# AXOD/AXODE (AX4S) UPDATE HANDBOOK

# INTRODUCTION

This updated version of the AXOD "Update Handbook" will also cover the changes that occurred in the 1991 model year, when electronic controls were adapted to the AXOD transaxle, making it an AXODE, and now called an AX4S transaxle. We have included the changes on the AX4S transaxle up through and including model year 2002.

Figure 44

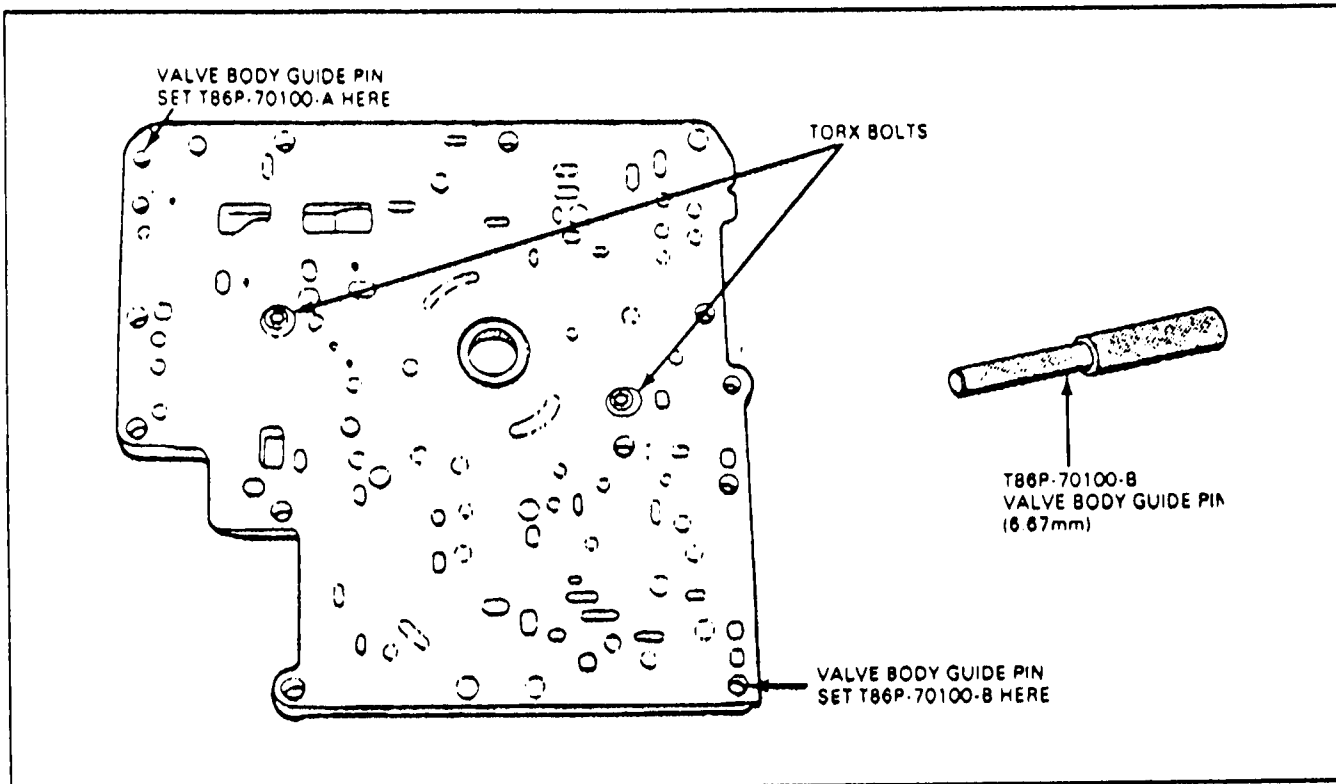
1. Position the spacer plate on the pump housing, using a new gasket.
2. Insert valve body guide pin T86P-70100-A (.271" Diameter) and valve body guide pin T86P-70100-B (.262" Diameter), as shown in Figure 44.
3. Install two "Torx" bolts and torque to 7 to 9 ft.lb.
4. Remove both guide pins.
5. Position the spacer plate on the valve body using a new gasket.
6. Insert two valve body guide pins T86P-70100-A (.271" Diameter), as shown in Figure 45.
7. Install two "Torx" bolts and torque to 7 to 9 ft.lb.
8. Position the oil pump on the valve body using a new gasket.
9. Insert pump body guide pin T86P-70370-A and valve body guide pin T86P-70100-C which is .245" in Diameter.
10. Install two valve body to oil pump retaining bolts and torque to 7 to 9 ft.lb.

Figure 48

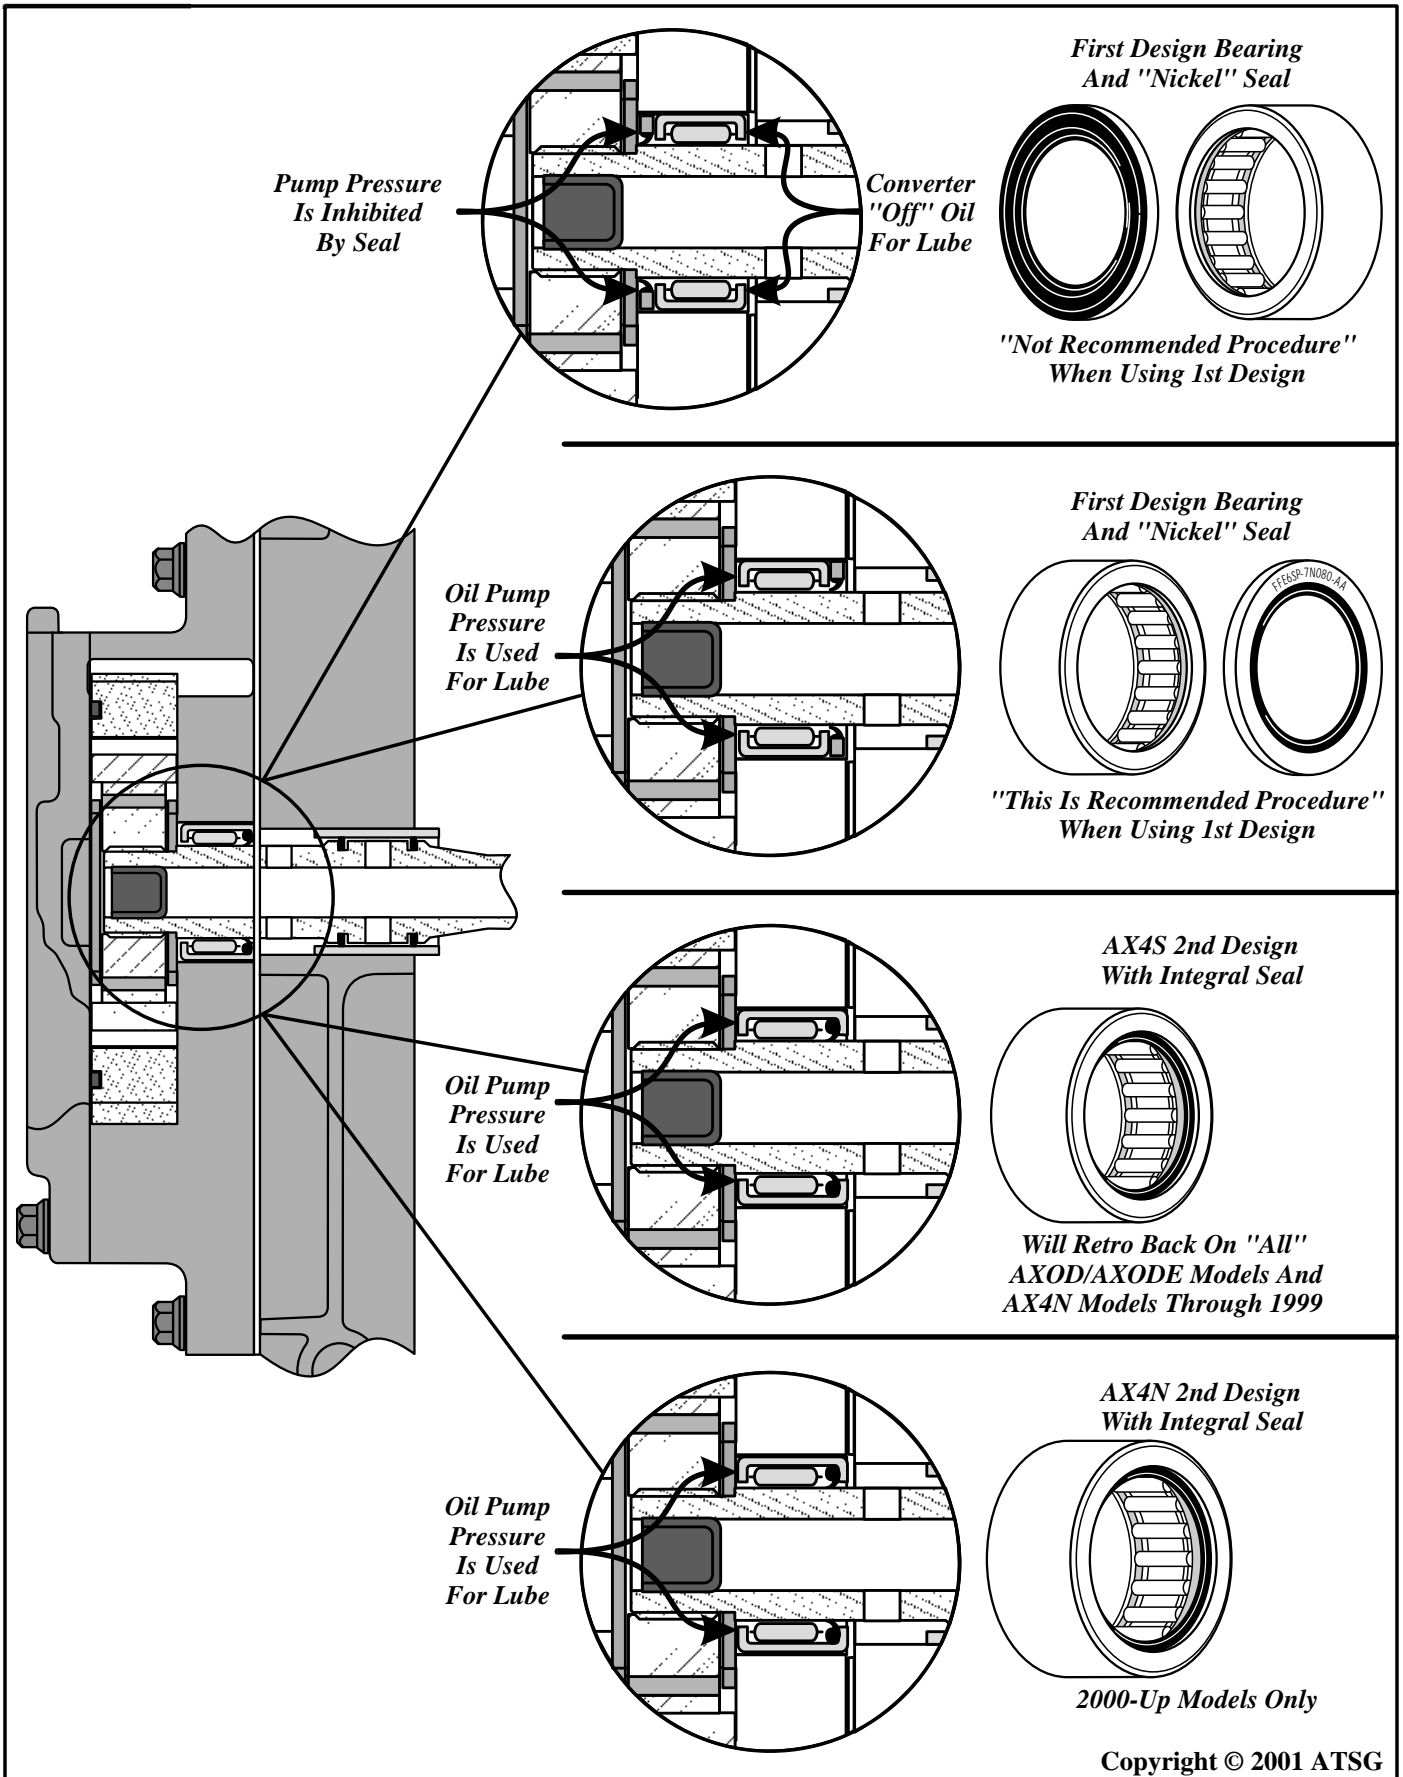
AXOD/AXODE (AX4S) - When using the 1st Design bearing with the "Nickel" Seal, install the seal on the valve body side, with the part number facing up, as shown in Figure 48. When using the 2nd Design bearing with the integrated seal, *which is recommended*, install the bearing assembly with the integrated seal facing the valve body side. The 2nd Design Bearing and Seal assembly *will retro-fit back on all* AXOD, AXODE and the AX4N up through 1999.

Figure 55

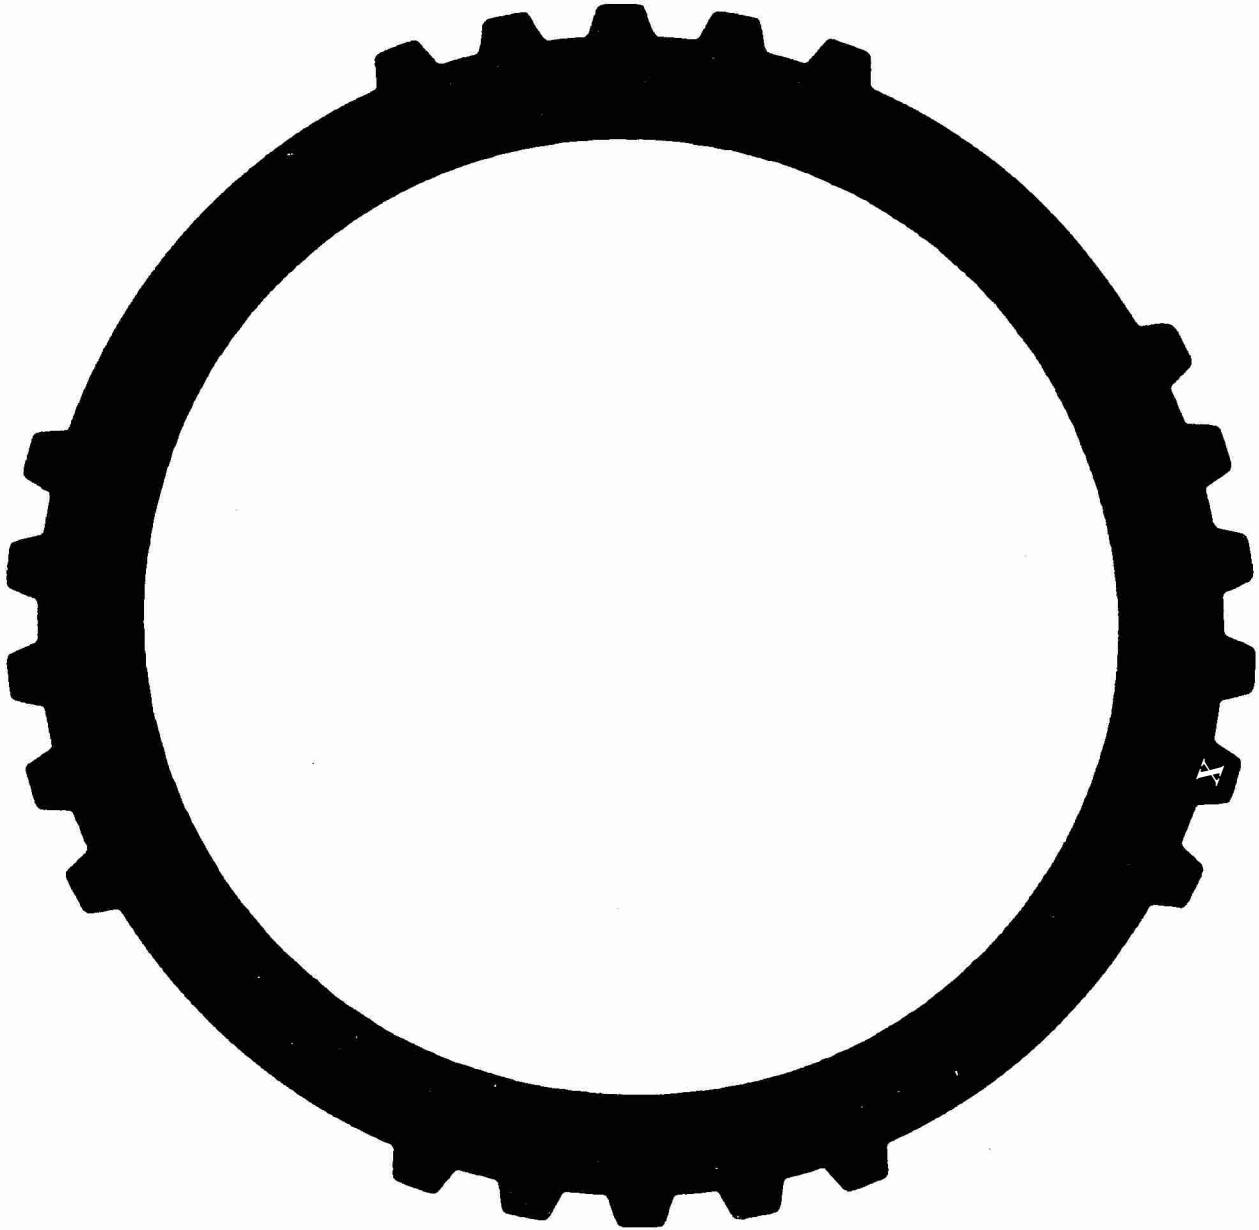
2ND DESIGN - Has 21 external teeth, inside diameter of 4.730", material thickness of .075", identified with letter "X" stamped on 1 tooth, and was used from 1989-1991. (See Figure 55).

Figure 56

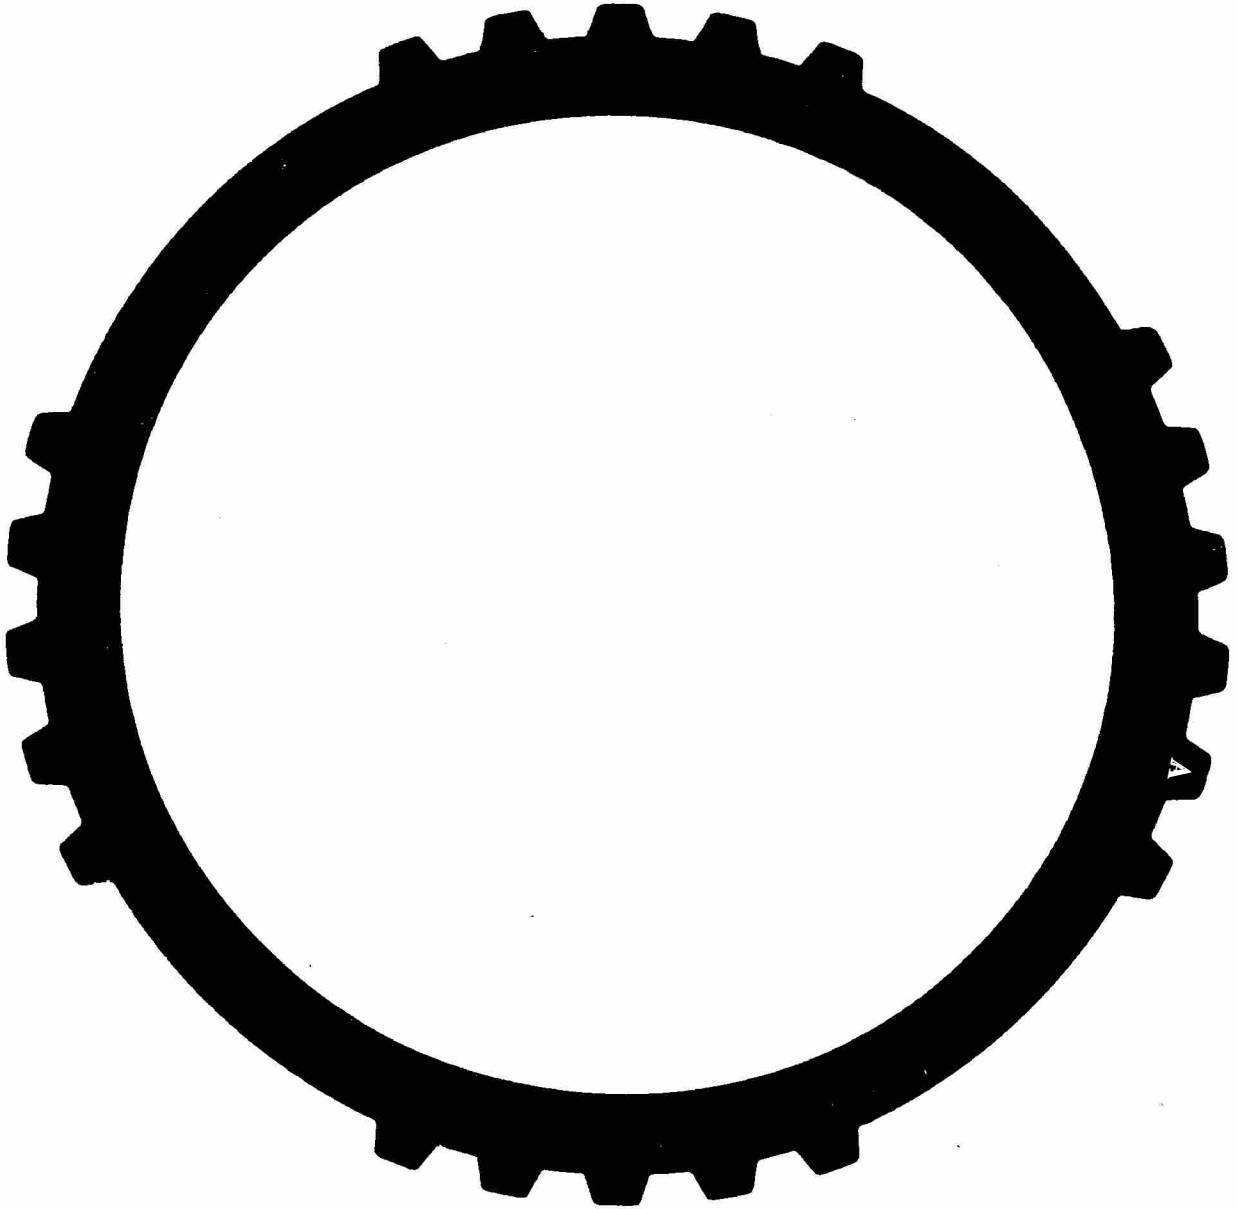
3RD DESIGN - Has 21 external teeth, inside diameter of 4.930", material thickness of .083", identified with letter "A" stamped on 1 tooth, used in 1992 and later models. (See Figure 56).

The 3rd design forward clutch wave plate was associated with a change in the entire forward clutch pack and should be used *Only* with the later design forward clutch pack, which are a larger inside diameter.

Figure 57

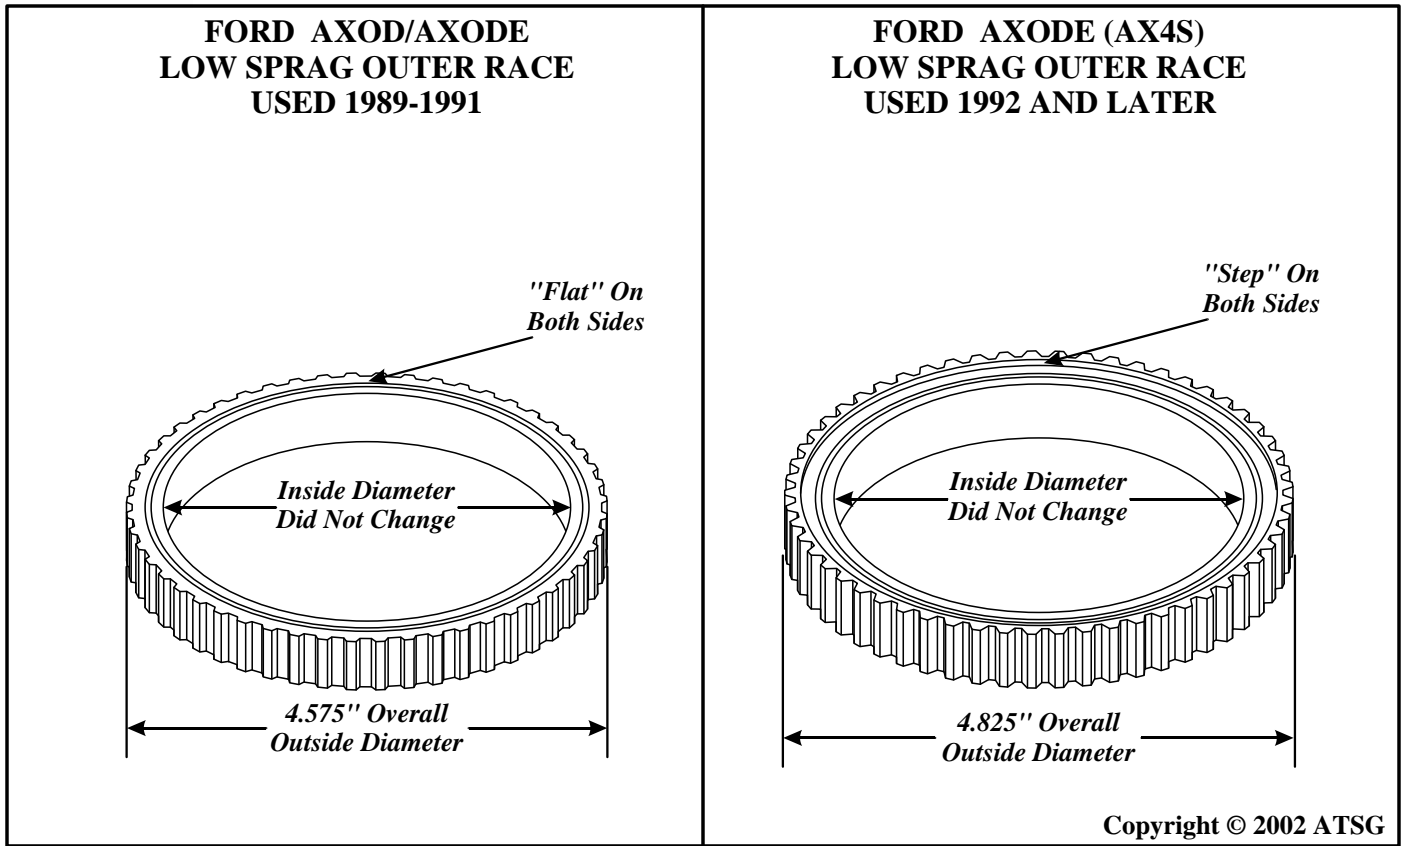
- (1) LOW SPRAG OUTER RACE - The outer diameter of the race was increased from 4.575" to 4.825", and the width of the race was increased from .600" to .725", as shown in Figure 57. *The Inside Diameter of the sprag race Did Not Change.*

Figure 58

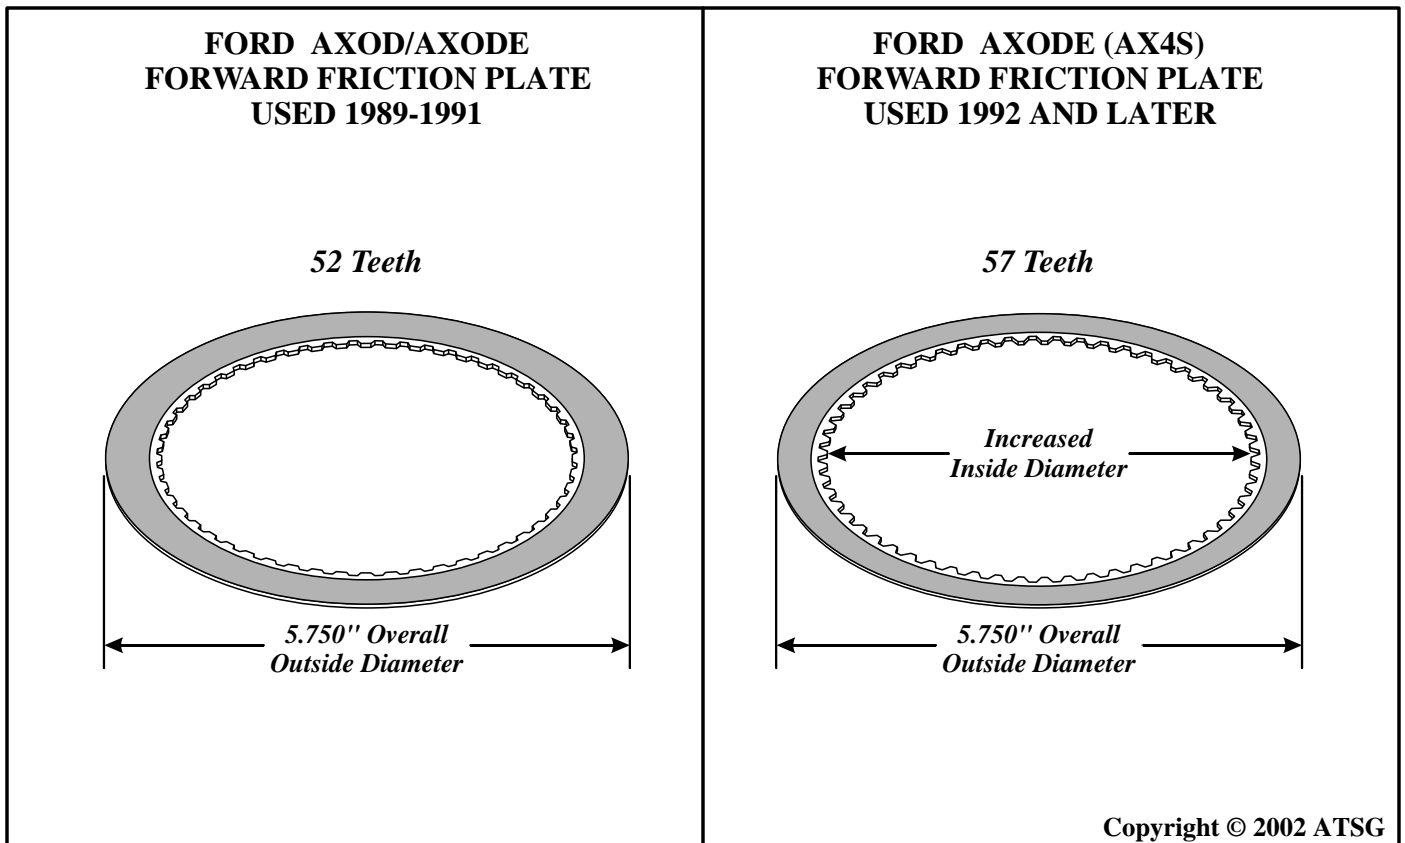
- (2) FORWARD CLUTCH FRICTION PLATES - Have an increased amount of teeth to 57 Teeth from the previous 52 Teeth, to accommodate the increased diameter of the sprag outer race, as shown in Figure 58.

Figure 59

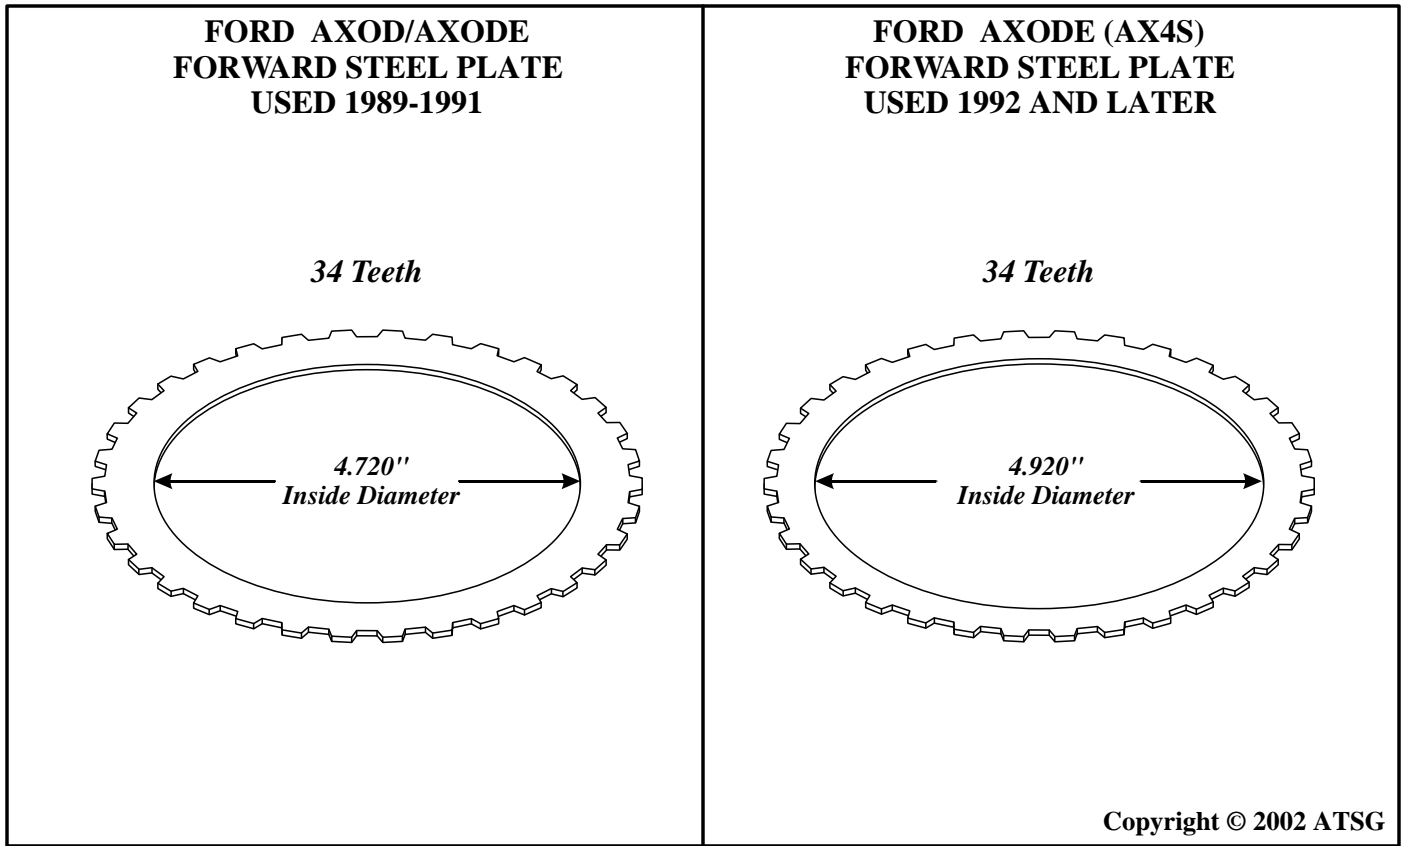
- (3) FORWARD CLUTCH STEEL PLATES - Have an increased inside diameter to 4.920" from the previous 4.720", to accommodate the increased diameter of the sprag outer race, as shown in Figure 59.
